**IMPACT AND IMPLEMENTATION REPORT (IIR) – SUMMARY SECTION**
*(For AEMO to complete and administer)*

<b>Issue Number</b>	IN026/16 and includes, IN011/16, IN012/16, IN015/16, IN017/16, IN024/16, IN027/16, IN021/15, IN025/15, IN010/17 and IN005/17.		
<b>Impacted Jurisdiction (s)</b>	SA and NSW/ACT.		
<b>Proponent</b>	Danny McGowan	<b>Company</b>	AEMO
<b>Affected Gas Markets(s)</b>	Retail	<b>Consultation process (Ordinary or Expedited)</b>	Expedited
<b>Industry Consultative forum(s) used</b>	Gas Retail Consultative Forum (GRCF)	<b>Date Industry Consultative forum(s)consultation concluded</b>	28 September 2017
<b>Short Description of change(s)</b>	Minor changes to the gas Technical Protocols (TP).		
<b>Procedure(s) or Documentation impacted</b>	Refer to documents listed in section 2 of this Impact and Implementation Report (IIR).		
<b>Summary of the change(s)</b>	The minor TP changes proposed in this IIR involve aligning the documentation with existing operational processes. Majority of the changes were raised during the implementation phase of the NSW/ACT Retail Gas Project (NARGP).

## IMPACT & IMPLEMENTATION REPORT – DETAILED REPORT SECTION

### XML Sample

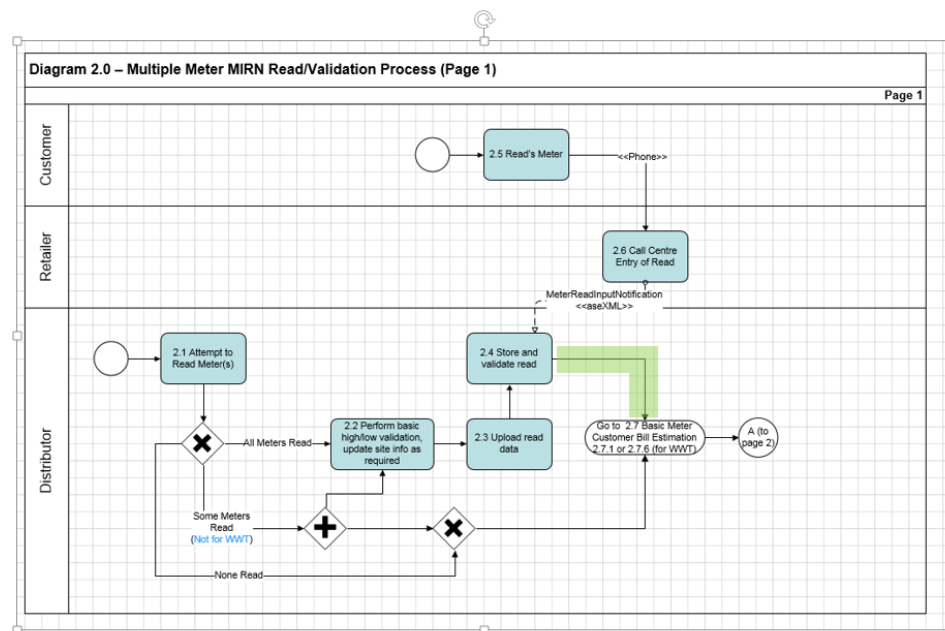
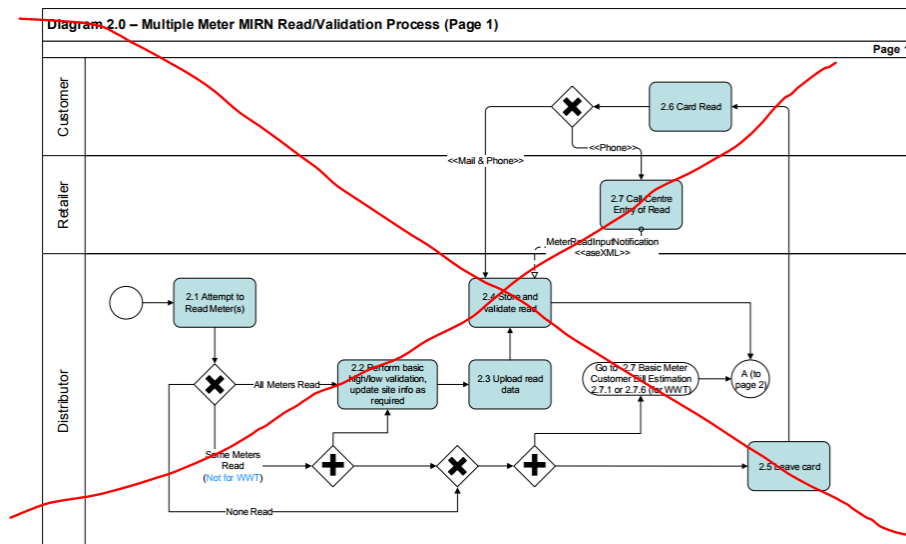
## IN005/17 Context:

Error with Sample "An error in the "PARTICIPANT BUILD PACK 5: NSW-ACT SPECIFIC BUILD PACK", in particular in page 188, the XML Sample section of 6.7.8 IAITImbalanceTradeRequest.

As there are missing elements in the given XML Sample, GRMBS would reject such transaction when processing it.

## Proposed changes to section 6.7.8:
